Dam Safety Assessment of CCW Impoundments

Chesterfield Power Station

September 29, 2010

FIGURE 3

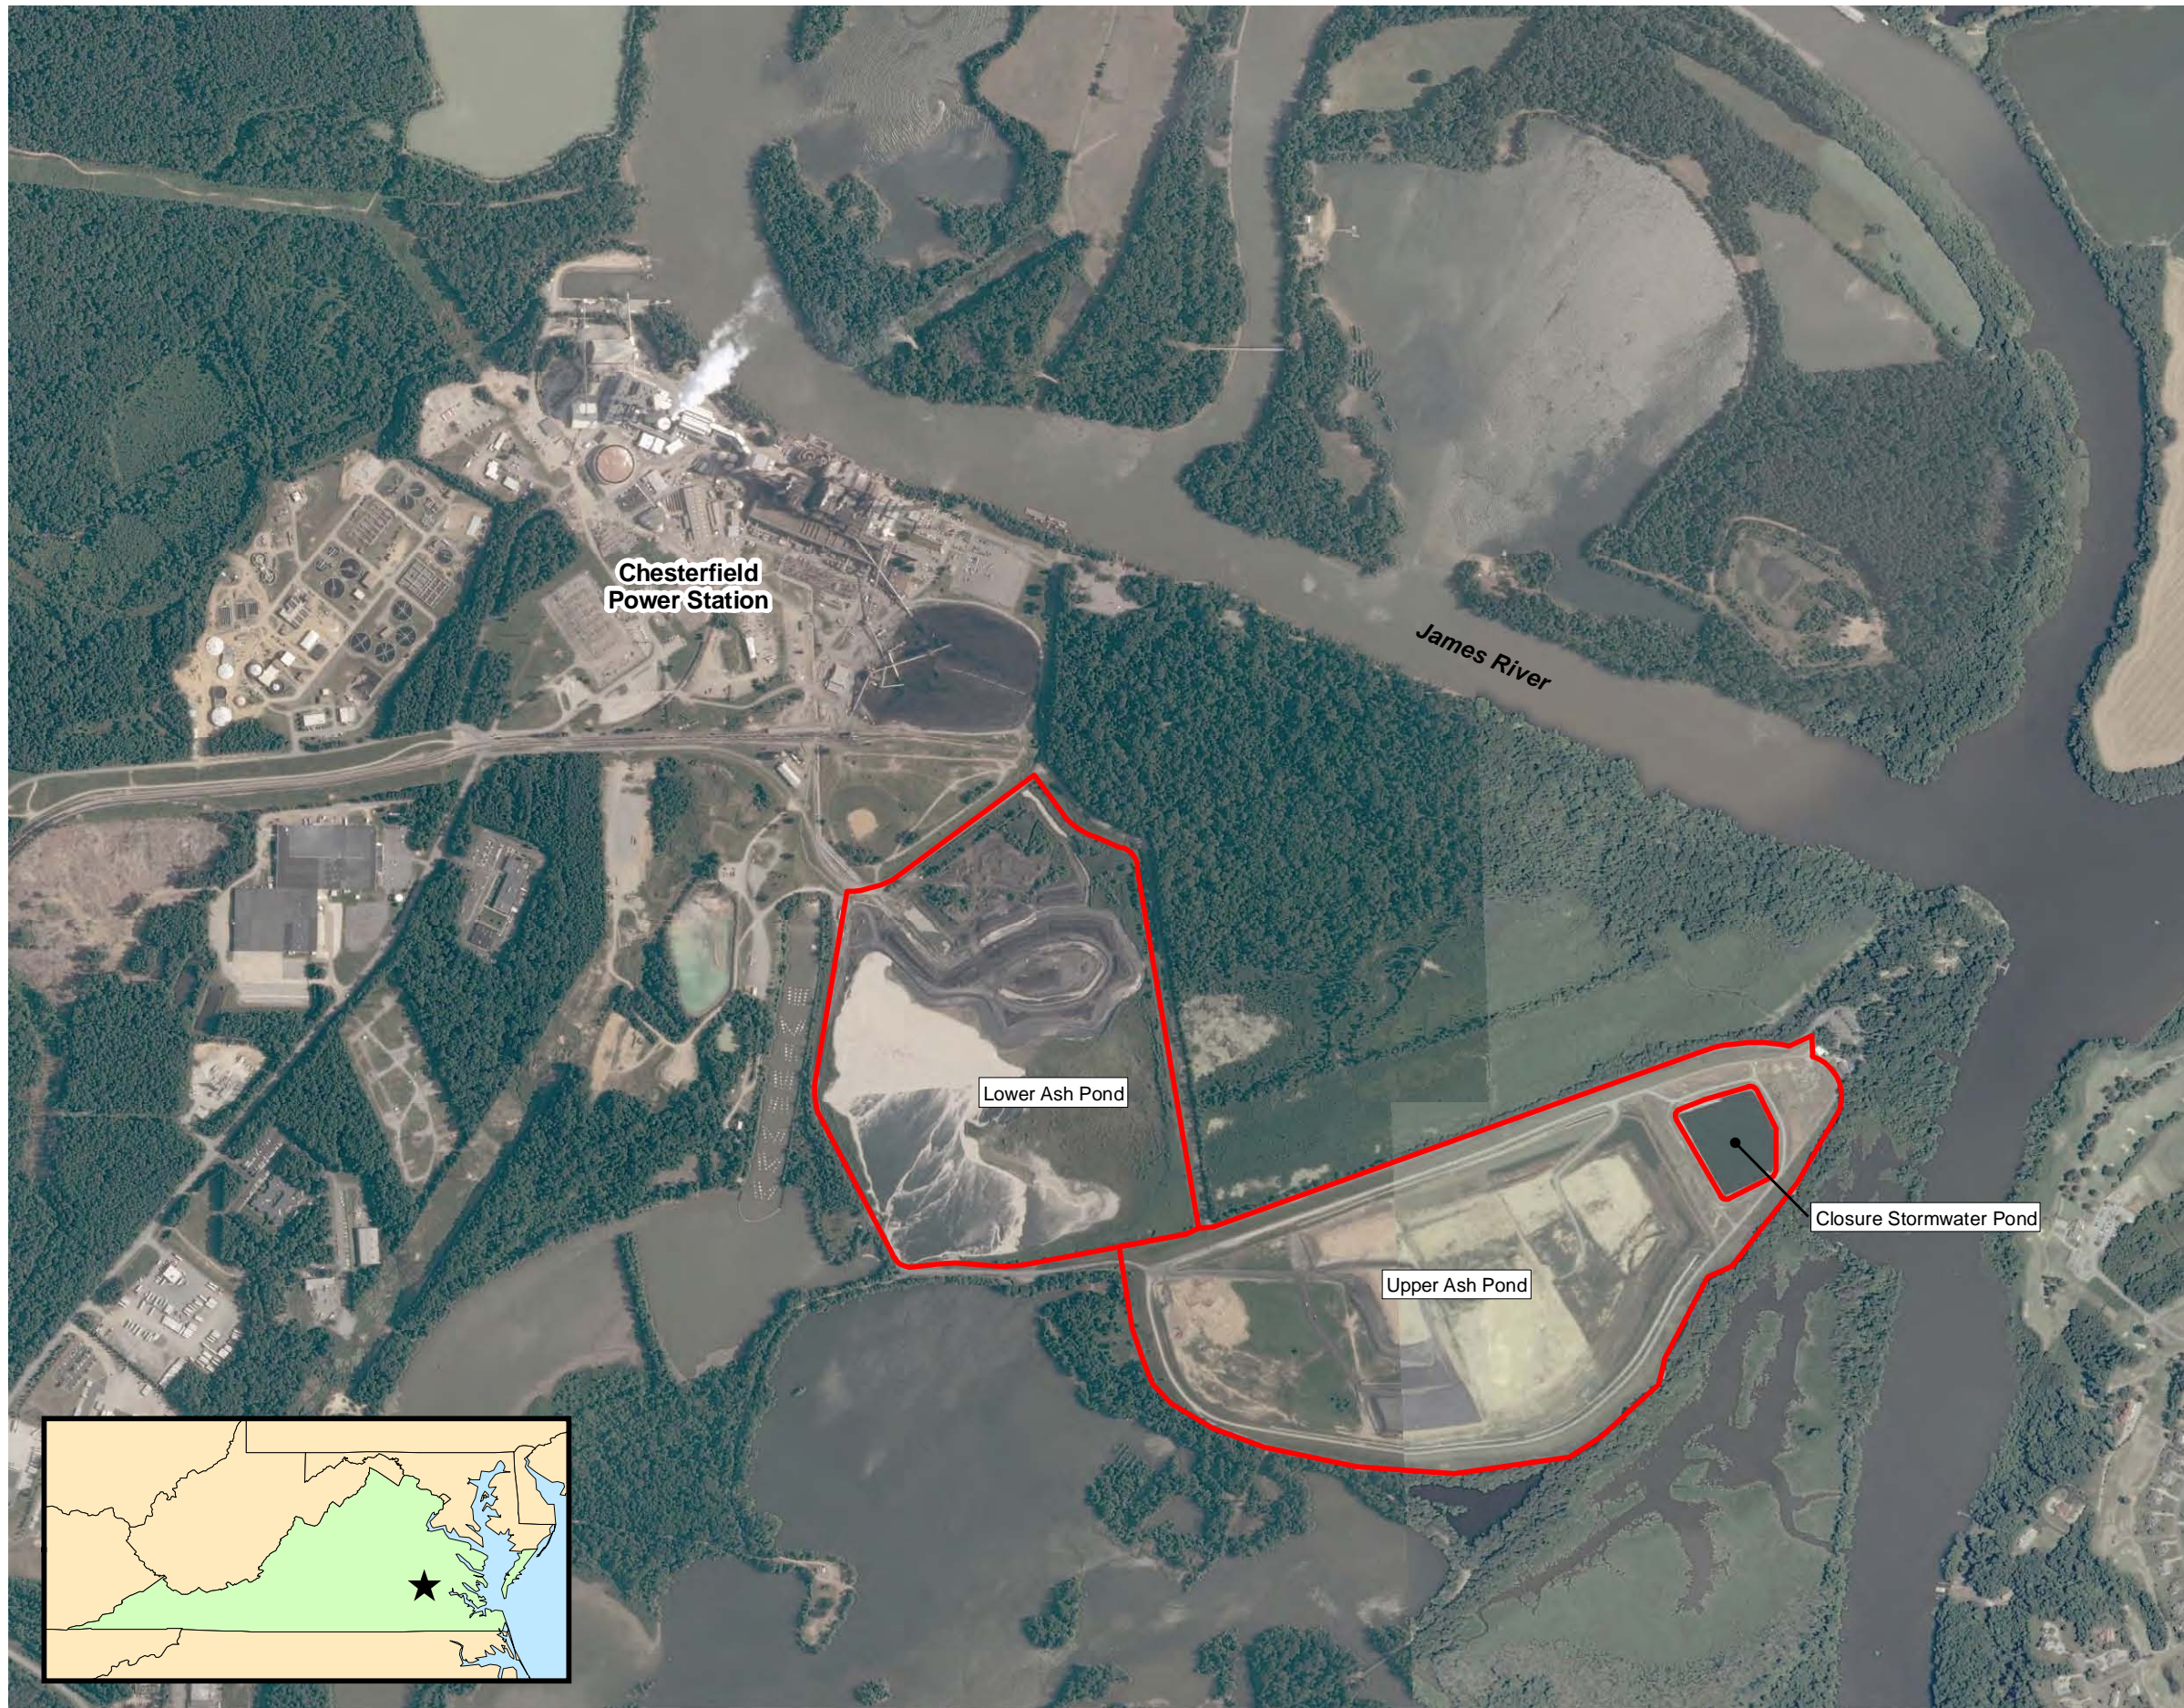
- As can be seen in Figure 3, the CCW has accumulated above the normal pool level over an estimated 40 percent of the pond area. Water in the pond is isolated to primarily the south half of the pond.
